H12080

DESCRIPTIVE REPORT

Project OPR-P184-RA-09
Pavlof Islands, Alaska
Vicinity of Poperechnoi Island
Scale 1:40,000
June – July, 2009
NOAA Ship *Rainier* (s221)
Chief of Party: Captain Donald W. Haines, NOAA

Revisions and Corrections Compiled During Office Processing and Certification

Figure 3: Contemporary surveys that junction with H12080

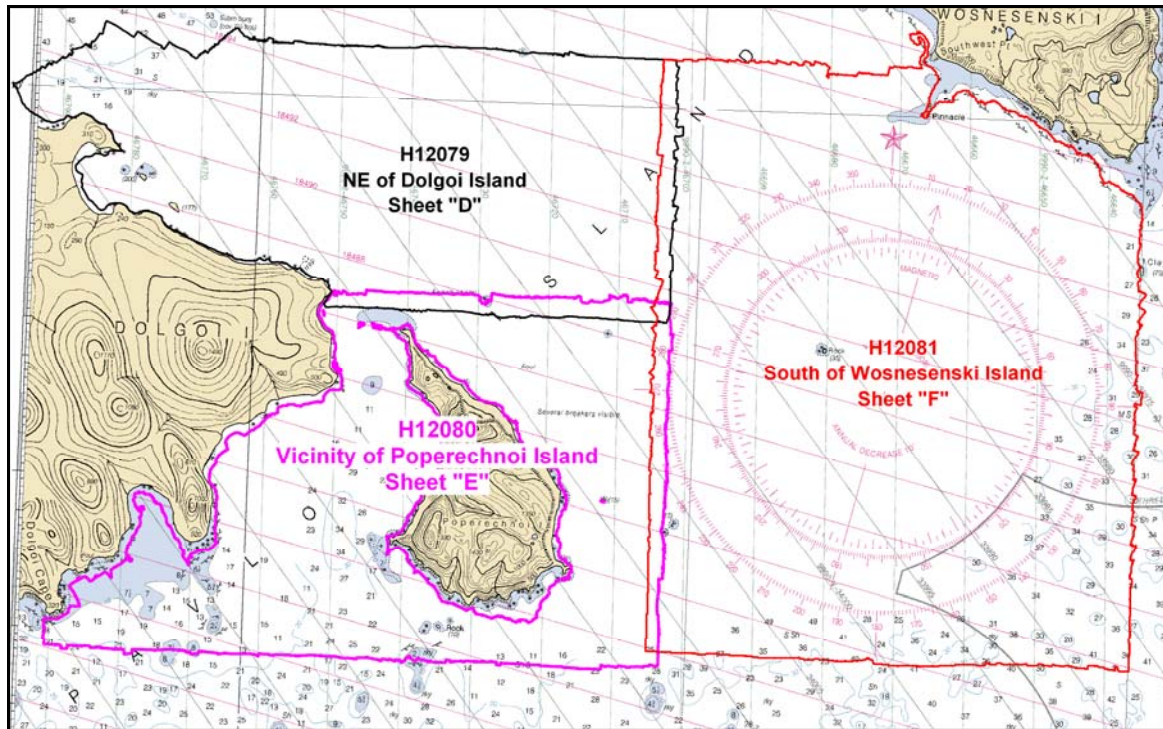
Survey H12080 junctions with H12079, which is Sheet D of the same project, and H12081, which is Sheet F of the same project (table 3).⁶ The sheet limits and area of overlap for Sheets D and F are shown in Figure 3.

Survey H12079 was completed concurrently with survey H12080 during project OPR-P184-RA-09. Soundings from H12080 were compared with sounding data from survey H12079 using the 2-D subset editor in CARIS HIPS. In general the area of overlap between H12080 and H12079 showed excellent agreement, with no discernable offset throughout most of the junction area.⁷ One minor exception is the 5-20 meter deep waters on the slope just east of Dolgoi Island where H12079 was found to be up to 0.15 meters shoaler than H12080.⁸ Additionally, in the 50-80 meter deep waters found in the eastern third of the junction, H12079 was found to be between 0.05 to 0.15 meters deeper than H12080.⁹

Survey H12081 was completed concurrently with survey H12080 during project OPR-P184-RA-09. Soundings from H12080 were compared with sounding data from survey H12081 using the 2-D subset editor in CARIS HIPS. The area of overlap between H12080 and H12081 showed excellent agreement, with no discernable offset throughout most of the junction area.¹⁰ Agreement was particularly good in the shoaler areas with a hard, rocky bottom. The largest differences observed, up to 0.3 meters, were observed in deeper waters with depths between 50-80m on slopes where the point cloud tended to spread out and the launches were operating in low frequency mode.¹¹

⁶ H12080 also junctions with H11903 from OPR-P184-RA-08. A common junction was made with H11903 and H12079 which have already been compiled. A junction with H12081 will be made when that survey is compiled.

⁹ Given the depth of water in the area, the discrepancy in the junction area is acceptable.

¹¹ Given the depth of water in the area, the discrepancy in the junction area is acceptable.

Figure 7: Holidays along shore due to kelp

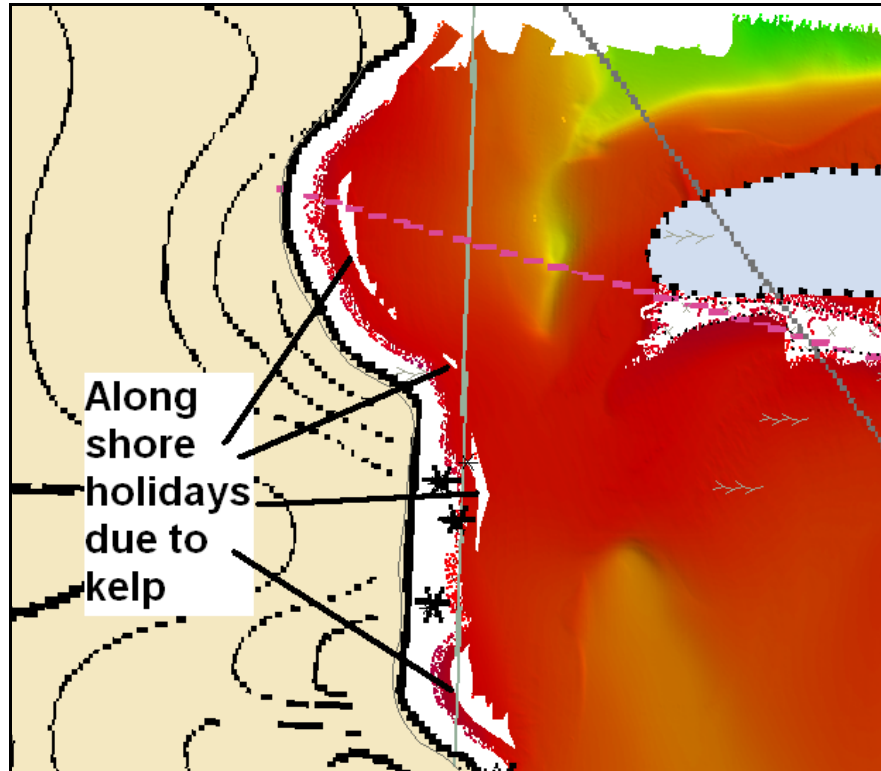
Holidays are present as stripes parallel to shore between $55^{\circ} 07' 14.74''$ N, $161^{\circ} 38' 24.83''$ W and $55^{\circ} 06' 25.24''$ N, $161^{\circ} 37' 56.9''$ W (figure 7). Two of these holidays are inshore of the 8m depth curve but the gap is greater than 25 meters. A third holiday extends into waters greater than 8m of depth. Since the inner line of tilted 8125 data was acquired at a high stage, the kelp was standing upright supported by the high water. When the offshore lines were run at a lower stage of tide the kelp, no longer supported by a full column of water, was allowed to lie on the surface. This resulted in a thick bed of surface kelp which preventing junction with the inshore data.¹⁸

¹⁸ The holiday was examined and no navigationally significant features were discovered based on the data surrounding the holiday. The larger holidays have been preserved in the HCell. Depths and kelp features should be charted as depicted in the HCell.

Figure 8: Holidays due to a failing surface sound velocimeter on RA-1

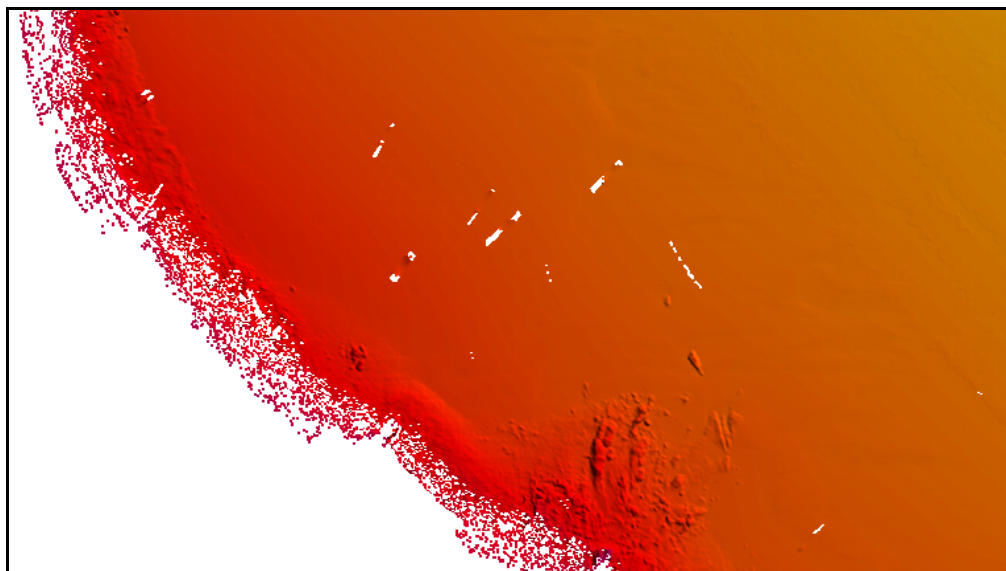
Numerous holidays are present in the vicinity of $55^{\circ} 06' 53.14''$ N, $161^{\circ} 36' 03.43''$ W due to faulty SV on RA-1 (figure 8). As previously discussed, the Reson 8125 multibeam sonar installed on *Rainier* launch 1101 (RA-1) displayed numerous momentary sound velocity 'blowouts' due to a failing Digibar surface sound velocimeter. The rejection of these blowouts in CARIS resulted in holidays. The corresponding multibeam backscatter side scan was examined and no navigationally significant items were found.¹⁹

¹⁹ Concur. Chart depths as depicted in the HCell.

Figure 9: Down slope holidays in an area of extreme topography

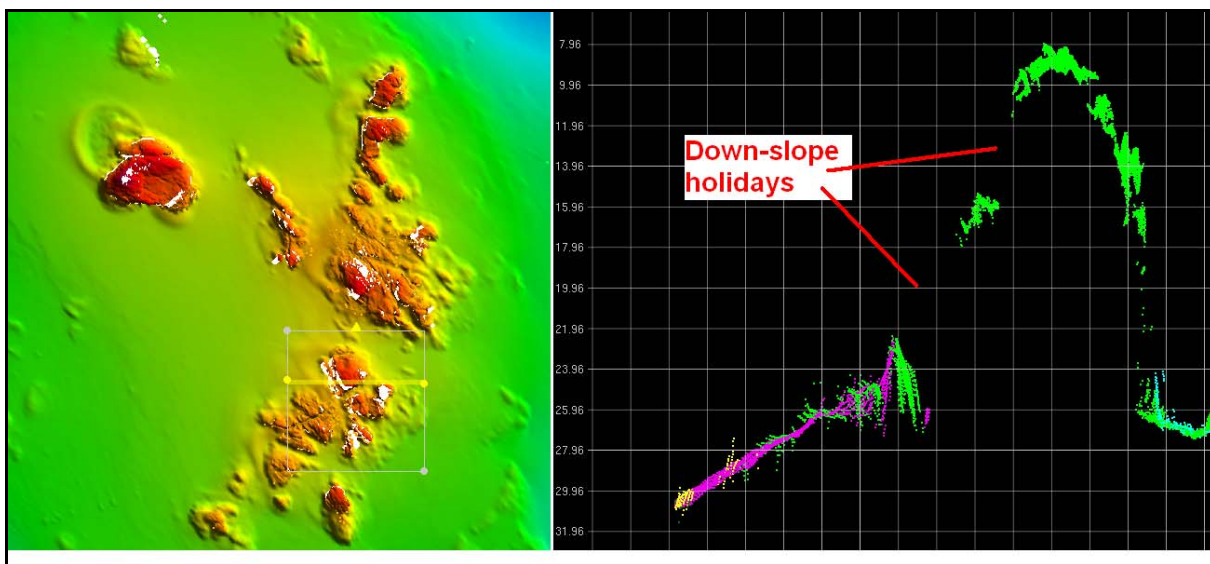
Numerous holidays are present in the vicinity of 55° 06' 57.78" N, 161° 31' 39.2" W (figure 9). Due to the extremely rocky and irregular seafloor in this area, numerous holidays due to acoustic shadowing and the lack of returns from away-sloping features resulted in many holidays. Examination by the hydrographer indicates that least depths on all of the features in this area were ensonified.²⁰

²⁰ Concur. Chart depths and features as depicted in the HCell.

Figure 14: Shifted depths and contour lines between charts 16549 and 16551

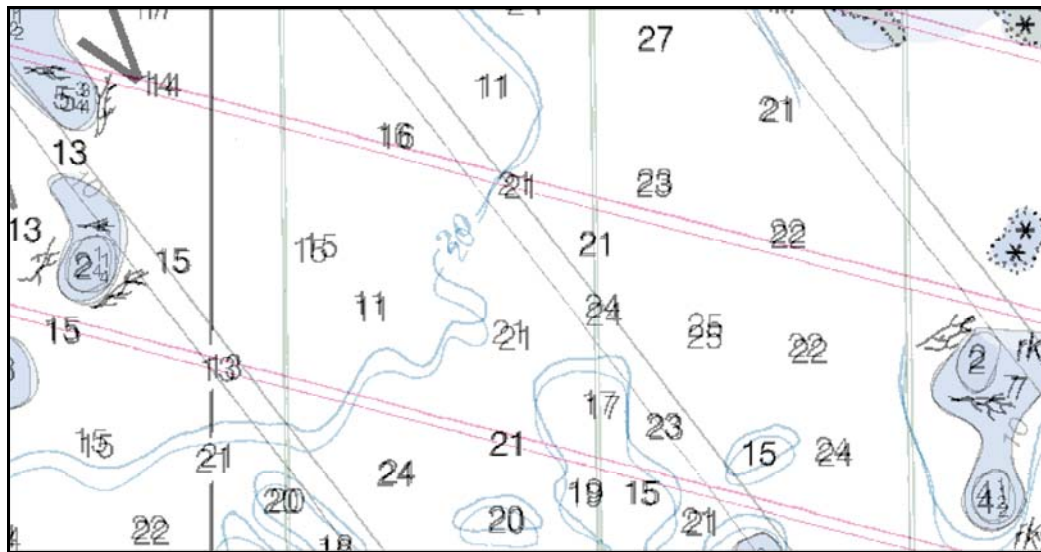
The majority of H12080 was previously unsurveyed and devoid of charted depths except along the southern edges of the sheet. Some additional scattered depths are present in the channel between Dolgoi and Poperechnoi Islands where apparently some recon lines were run. In spite of the fact that charts 16549 and 16551 are the same scale and share the same depths in their common area, there is a slight discrepancy with the positions of a portion of these depths. Some of the depths line up perfectly while others show offsets up to 70 meters in no consistent direction. Contour lines exhibit the same problem and some are even shaped differently (figure 14).²³

²³ For both 16549 and 16551, update contours based on new survey data and depths as depicted in the HCell.

Figure 15: Shoreline discrepancies between charts 16549 and 16551

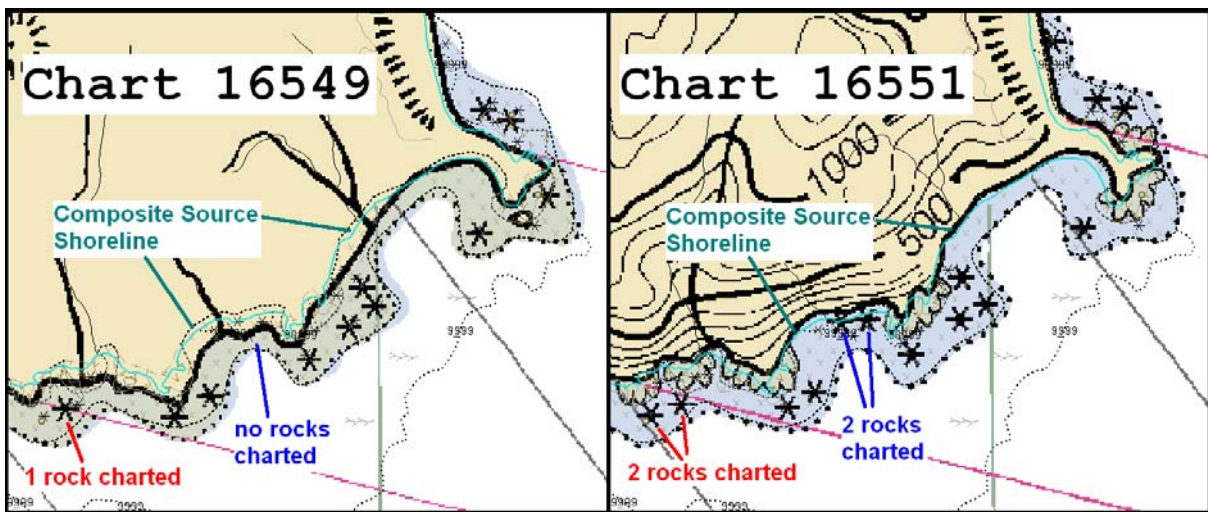
Discrepancies between the charted shoreline of 16549 and 16551 were noted as indicated in figure 15. The shoreline depicted on chart 16551 agrees reasonably well with the composite source shoreline as provided with the project; however a significant offset is apparent between composite source and the shoreline of chart 16549. A more detailed high water line and additional rocks and ledges are also found on chart 16551 when compared to chart 16549. Even though both charts are of the same scale, the shoreline of chart 16551 appears to have been compiled at a higher resolution than that of chart 16549. The charted 16551 shoreline agrees much more closely with shoreline observed in the field in the near shore areas of Poperechnoi and Dolgoi Islands than that of chart 16549. However, for some of the small islands offshore of Poperechnoi Island, H12080 bathymetry better matches the positions found on chart 16549.²⁷

²⁷ Update depths and features as depicted in the HCell. Update charted coastline based on the latest available GC shoreline.

Figure 16: The charted danger line enclosing the near shore rocks surrounding Poperechnoi Island is incorrectly charted with a green tint on chart 16549 (left) as opposed to the correct blue tint used on chart 16551 (right)

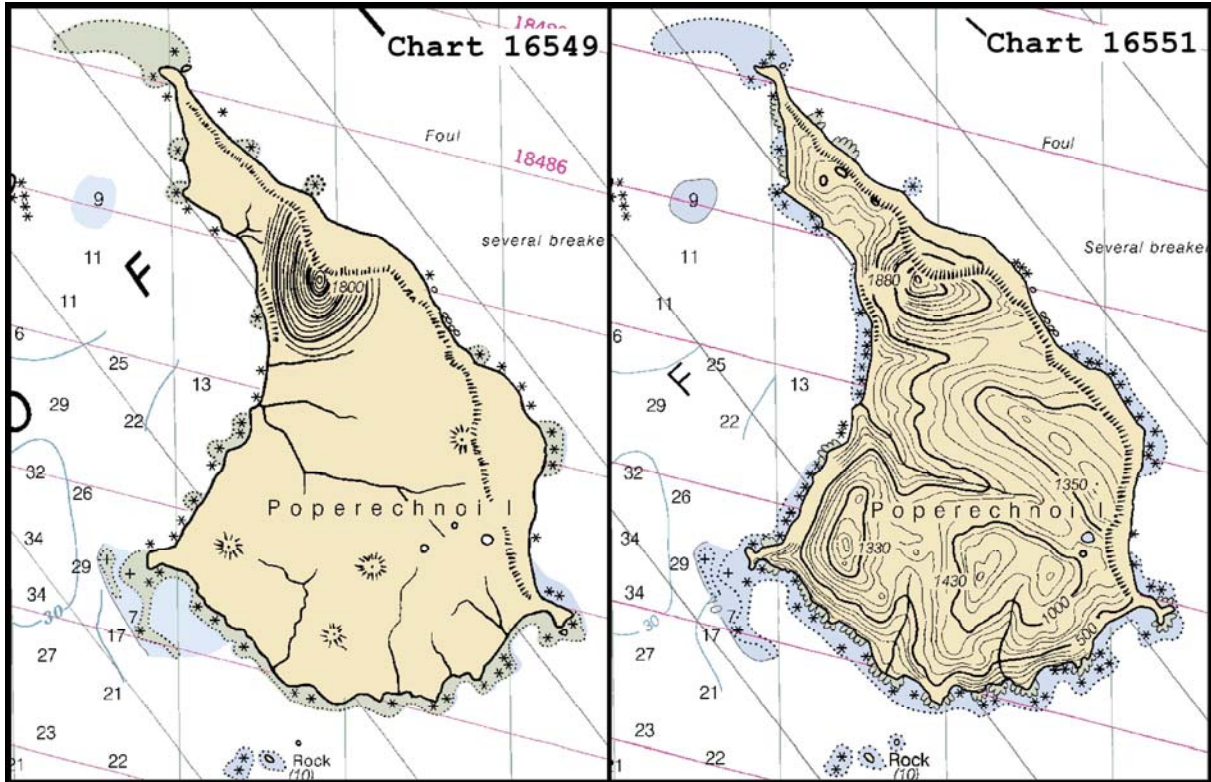
The dotted danger line on chart 16549 is depicted incorrectly. The placement of the danger line buffering the near shore rocks surrounding Poperechnoi Island is correct, except as modified in the field, but the area between danger line and mean high water (MHW) is tinted green, instead of blue. The contrast between charts 16549 and 16551 is shown below in Figure 16. The Hydrographer recommends adjusting the tint inshore of the charted danger lines on chart 16549 to blue.²⁸

²⁸ Concur with clarification. Recommend that chart 16549 be updated based the appearance of 16551 and update foul areas as depicted in the HCell. Update charted coastline based on the latest available GC shoreline.
